PROJECT
522 Flinders Lane
522 Flinders Ln
Melbourne VIC 3000

MINISTERIAL PLANNING REFERRAL

Melbourne City Council application number:	TPMR-2023-19
Department of Transport and Planning application number:	PA2302533
Applicant:	ICPF Nominees Pty Ltd
Owner:	ICPF Nominees Pty Ltd
Architect:	Hassell Architects
Address:	522-552 Flinders Lane, Melbourne
Proposal:	Demolition of the existing building and the construction of a multi-storey office building
Cost of works:	\$332 million
Date application received by the Melbourne City Council:	16 October 2023
Date amended application received by the City of Melbourne	1 March 2024
Responsible officer:	Matthew Mukhtar, Principal Urban Planner

DRAWING TITLE
ELEVATIONS - DETAIL

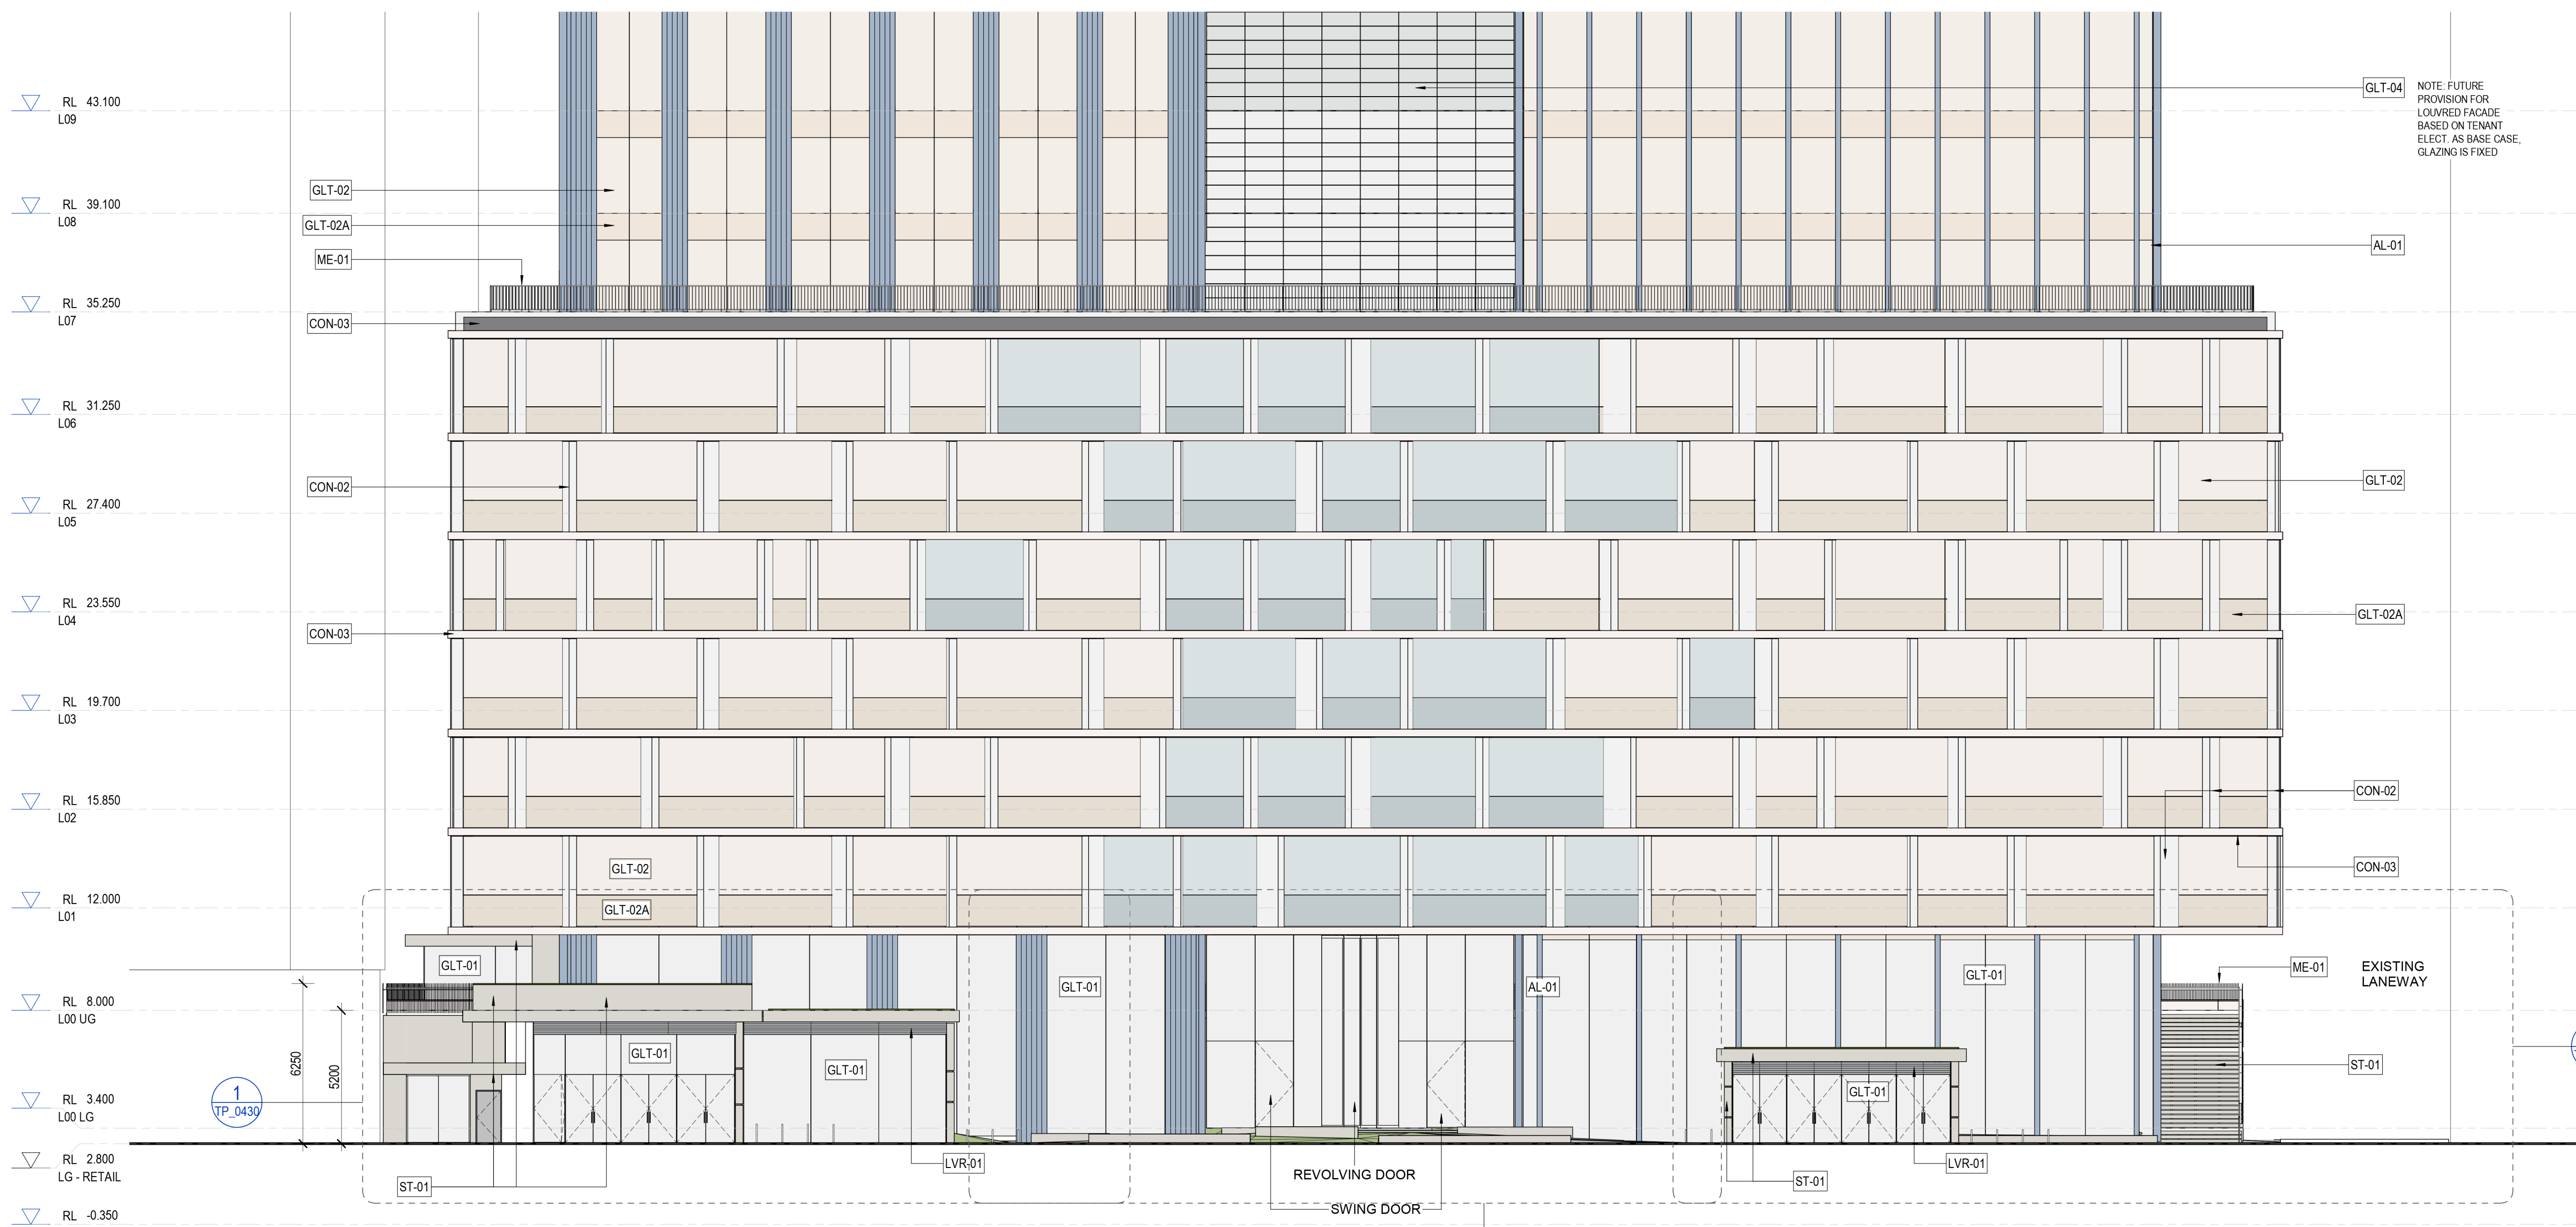
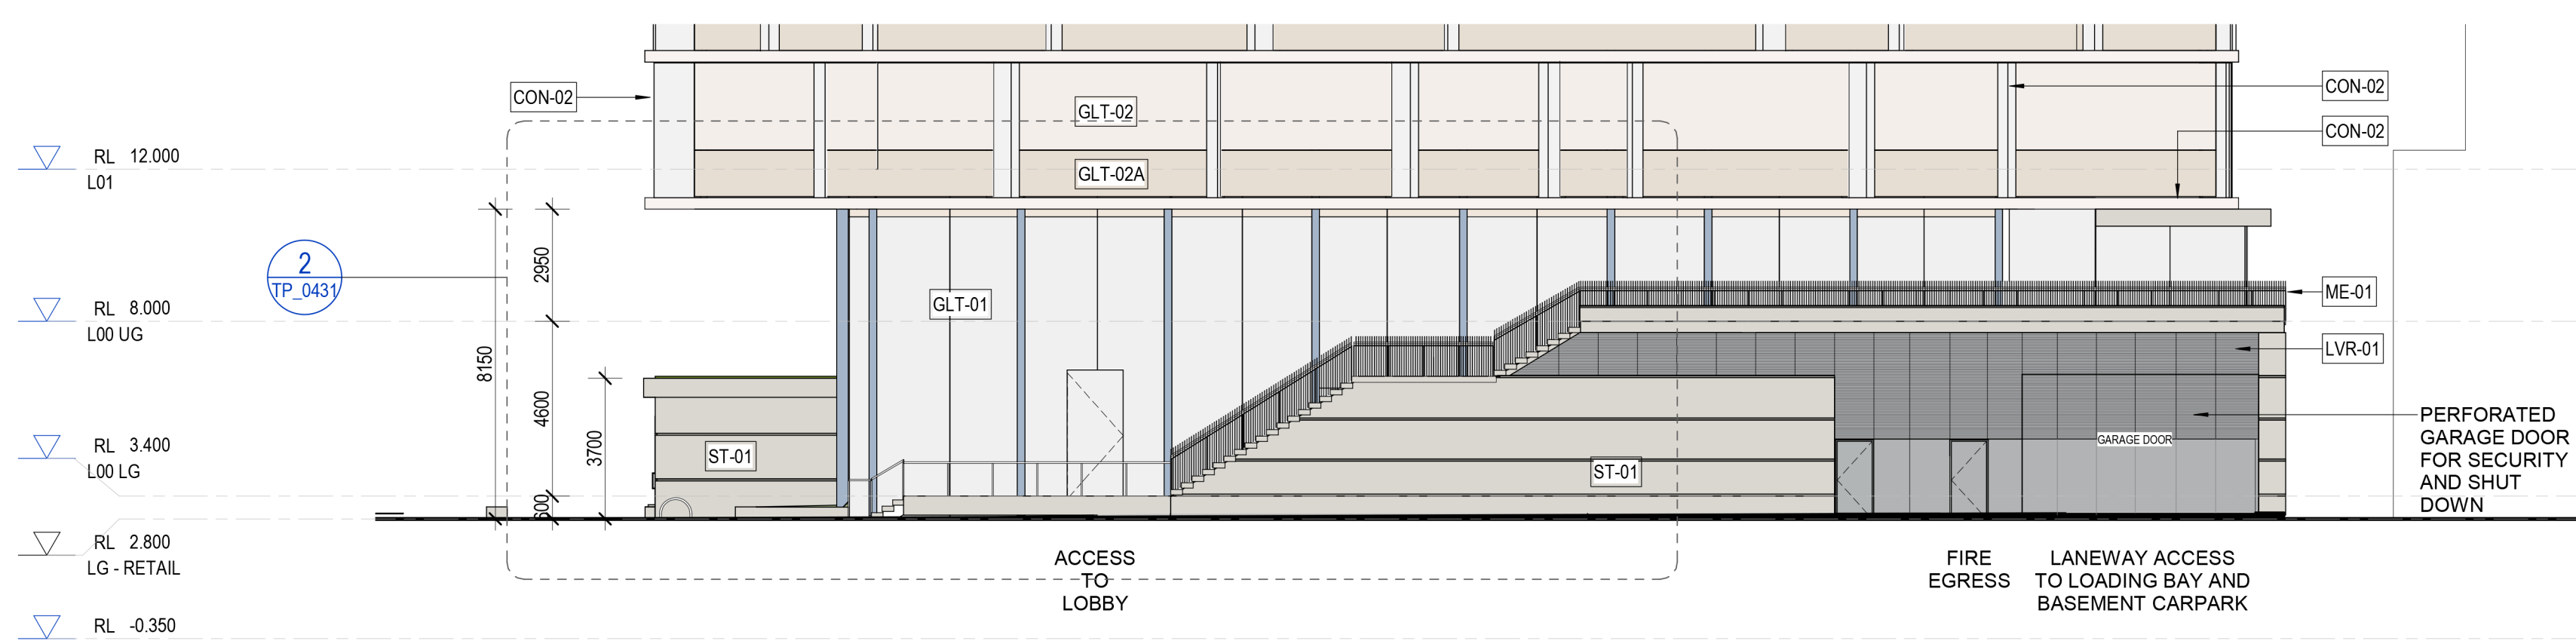
- Increasing the depth of the central tower indent by 500 mm (from 2500 mm to 3000 mm).
- Include a variation in podium glazing as shown in drawing TP_0403 (Elevations – Detail) prepared by Hassell Architects dated 18 March 2024.

- b. Include a variation in glazing within the podium generally in accordance with the discussion plan TP_0403 (Elevations – Detail) prepared by Hassell Architects dated 18 March 2024.

Figure 7 – Extract of TP_0403 (Elevations – Detail) prepared by Hassell Architects dated 18 March 2024

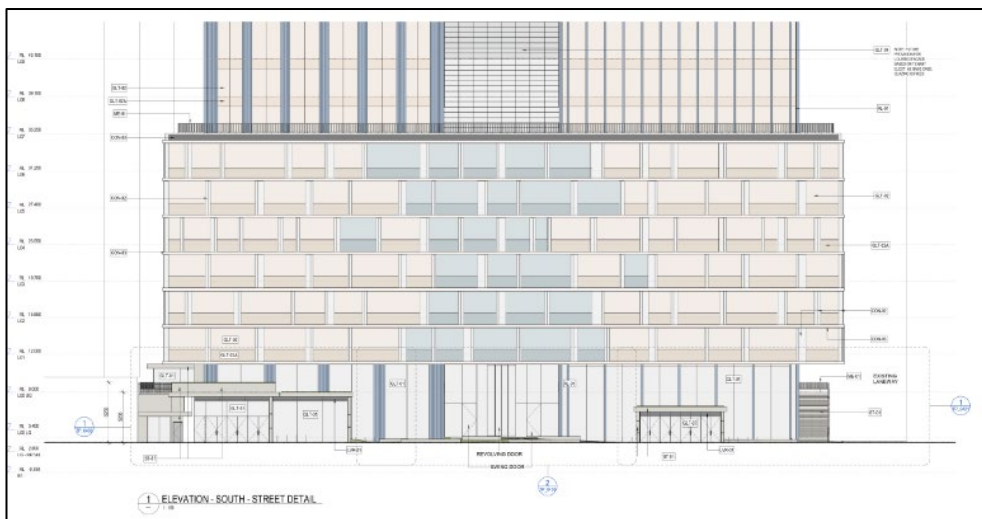
As described above, the VDRP recommended further subtle modulation to mark the primary pedestrian entrance from Flinders Lane. To achieve this the City Design department encouraged increasing the height of the pedestrian entrance by a storey. In response, the applicant provided revised plan TP_0403 (Elevations – Detail) prepared by Hassell Architects dated 18 March 2024 (see figure 7 below) which varies the glazing treatment above the pedestrian entrance to emphasise and reference the pedestrian entrance. The variation in the glazing, combined with the other modulations discussed above, provides for a fine grain and visually interesting street wall that responds to its context. The amended glazing proposition will be recommended to be included by way of condition.

The detailed design language of the podium will be further refined through a condition requiring a façade strategy which will strengthen the use of solid materiality to better reference the materials that characterise the immediate context.

Figure 9 – shadow assessment on 22 June 1:45pm prepared by the Department of Transport and Planning

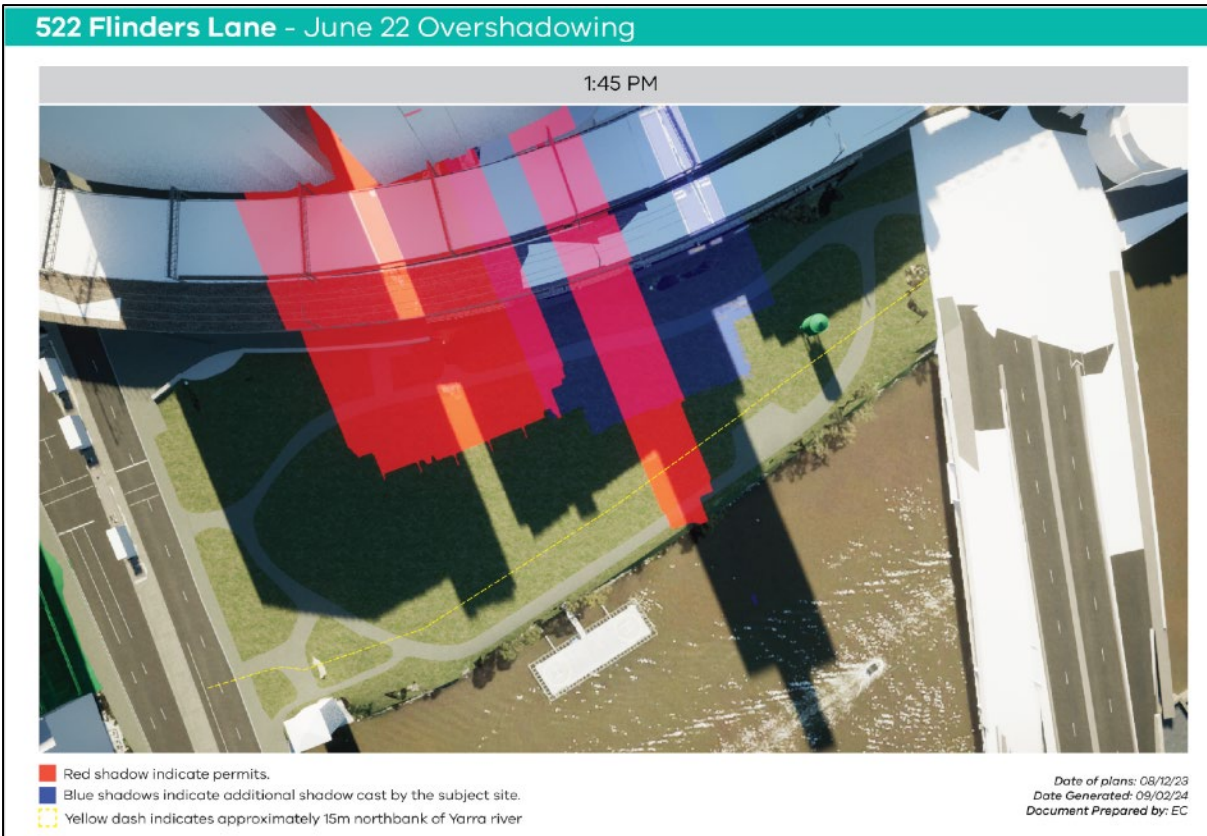
In regard to Batman Park, as figure 9 below shows, there is a period up to thirty minutes which occurs on June 22 (the winter solstice, being the greatest amount of shadows between 22 April and 22 September) which results in a maximum of approximately 98 m² being cast (or 0.69 per cent of the total park area). Batman Park is otherwise free from shadow between the applicable dates of 22 April to 22 September. The impact of this additional shadow on 22 June does not unreasonably prejudice the amenity of the space.

Figure 10 – proposed demolition plan (above) and proposed ground floor plan (below)

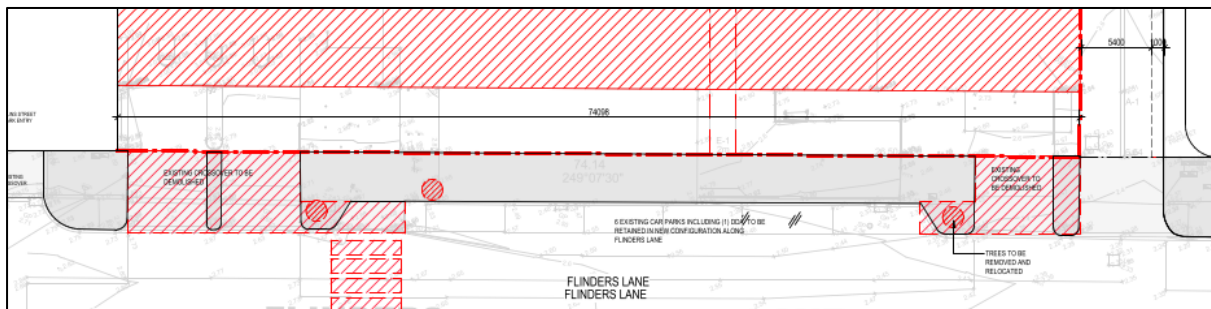
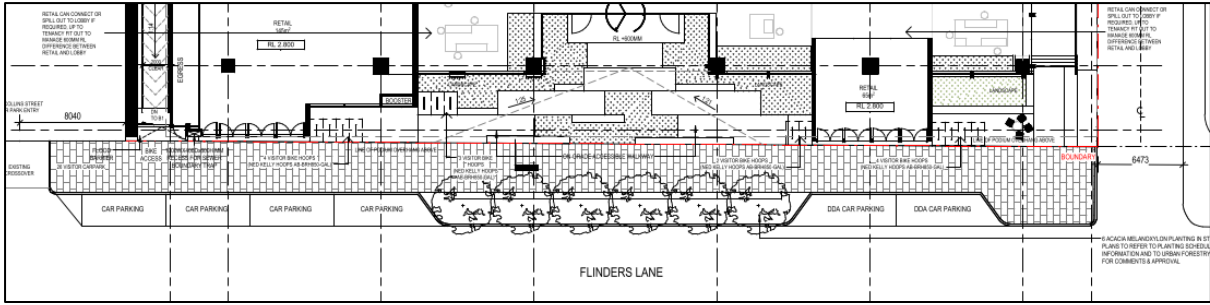
As discussed above, the proposal includes alterations to the Flinders Lane streetscape, including: removal and replacement of street trees, removal of crossovers, adjustments to the on-street car parking, and landscaping. This is depicted in figure 10 below.

With the exception of the removal of the crossovers (as they are not required by the proposed building), the details of works outside of the title boundary are recommended to be removed by condition. As identified by the City Infrastructure, Transport Engineering, and Urban Forestry and Ecology departments, there are a number of statutory processes that public street works must go through prior to approval (should they be approved). These processes may include public consultation. As such, the details must be removed for the purpose of this planning permit application.

- j. Delete any development within the Flinders Lane road reserve, with the exception of the removal of redundant vehicle crossovers.
- k. Where service areas within the basement are not independently accessed and/or rely on access over an adjoining car space, access required to the service area must be marked as a clearway zone.
